# FITZSIMONS GATEWAY MULTIFAMILY | SITE PLAN

LOT 2, BLOCK 1 FITZSIMONS PROMENADE SUBDIVISION FILING NO. 1 AMENDMENT 1  
LOCATED IN THE NORTHWEST 1/4 OF SECTION 1, TOWNSHIP 4 SOUTH, RANGE 67 WEST OF THE 6TH P.M.,  
CITY OF AURORA, COUNTY OF ARAPAHOE, STATE OF COLORADO

## AMENDMENTS

DATE:  
08/24/22 - SITE PLAN 01  
10/17/22 - SITE PLAN 02  
11/23/22 - SITE PLAN 03  
12/19/22 - SITE PLAN 04  
02/13/23 - SITE PLAN 05  
05/17/23 - MINOR AMD 01-1  
12/08/23 - MINOR AMD 01-2  
01/30/24 - MINOR AMD 01-3  
10/24/24 - MYLAR CHANGE

## SITE LIGHTING PHOTOMETRIC

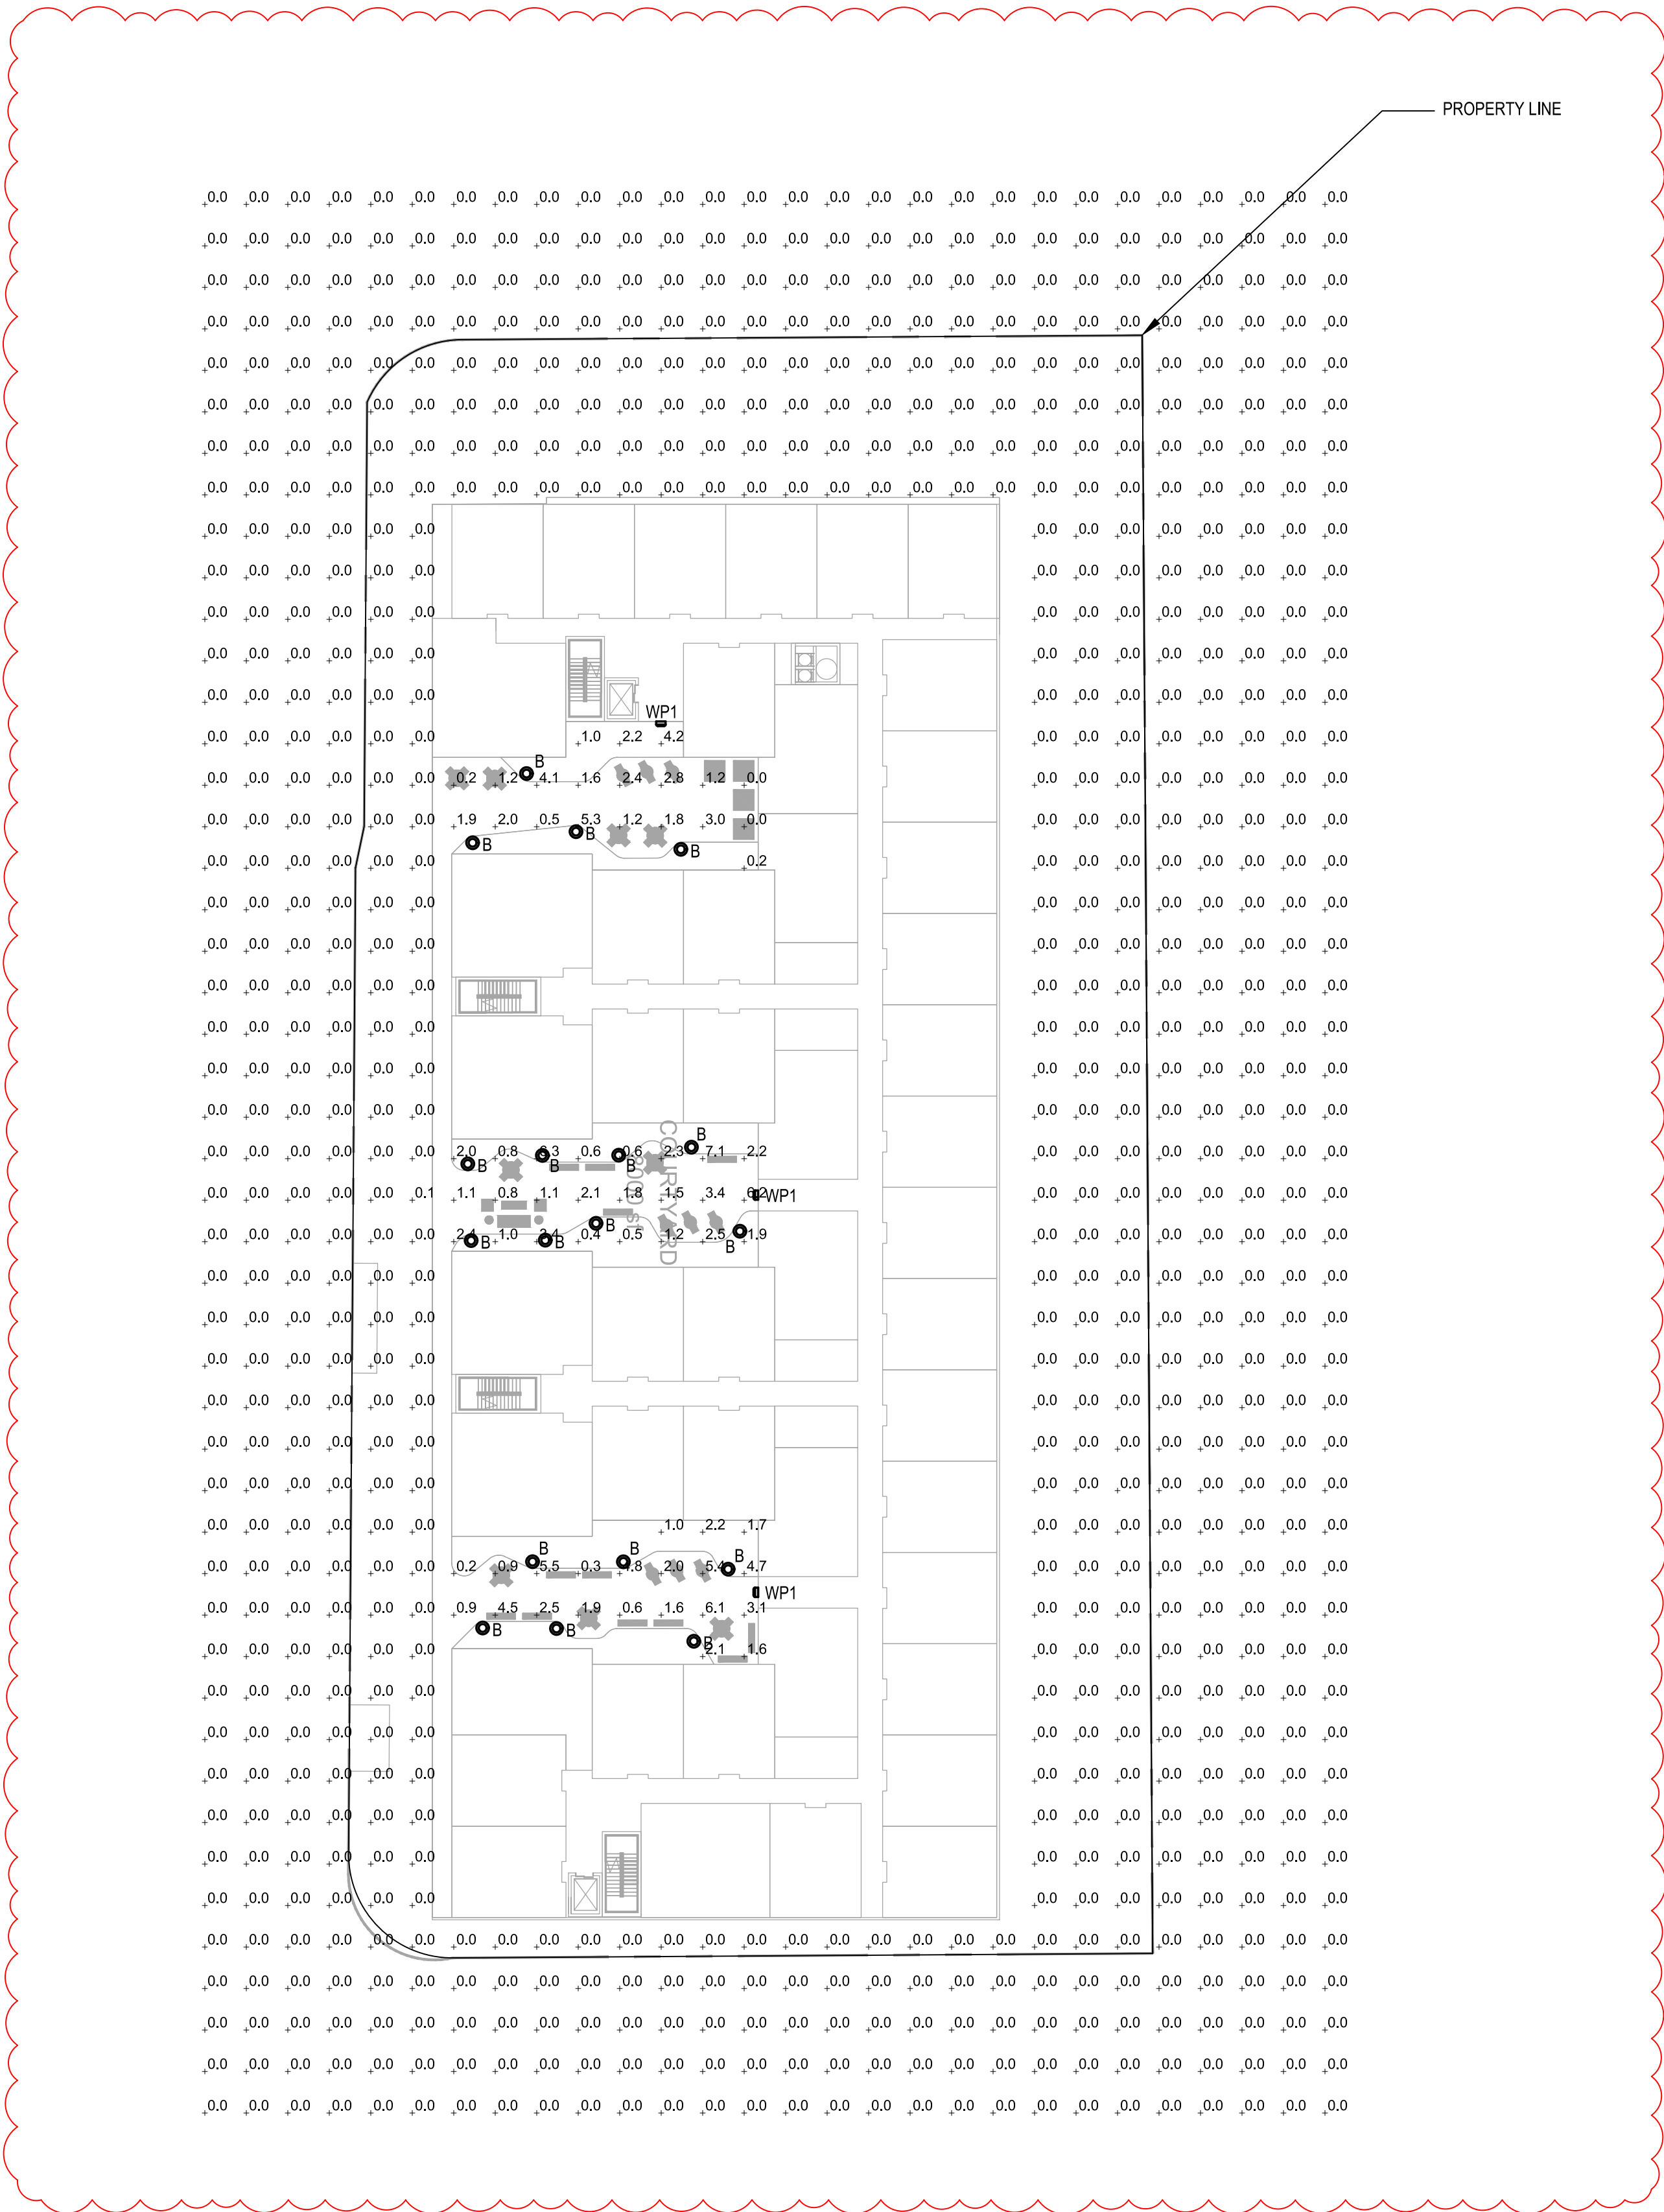
- LIGHT FIXTURES HAVE BEEN SWAPPED IN THE PLAZA ALONG COLFAX. WALL SCONCES, BOLLARDS, AND WALL PACKS HAVE BEEN SWAPPED FOR COMPARABLE FIXTURES FROM DIFFERENT MANUFACTURERS. MINOR CHANGES IN PHOTOMETRY, RESULTING FROM FIXTURE SWAPS ARE SHOWN

LIGHTING PLAN HAS NOT CHANGED. SOME FIXTURE SPECIFICATIONS REVISED.
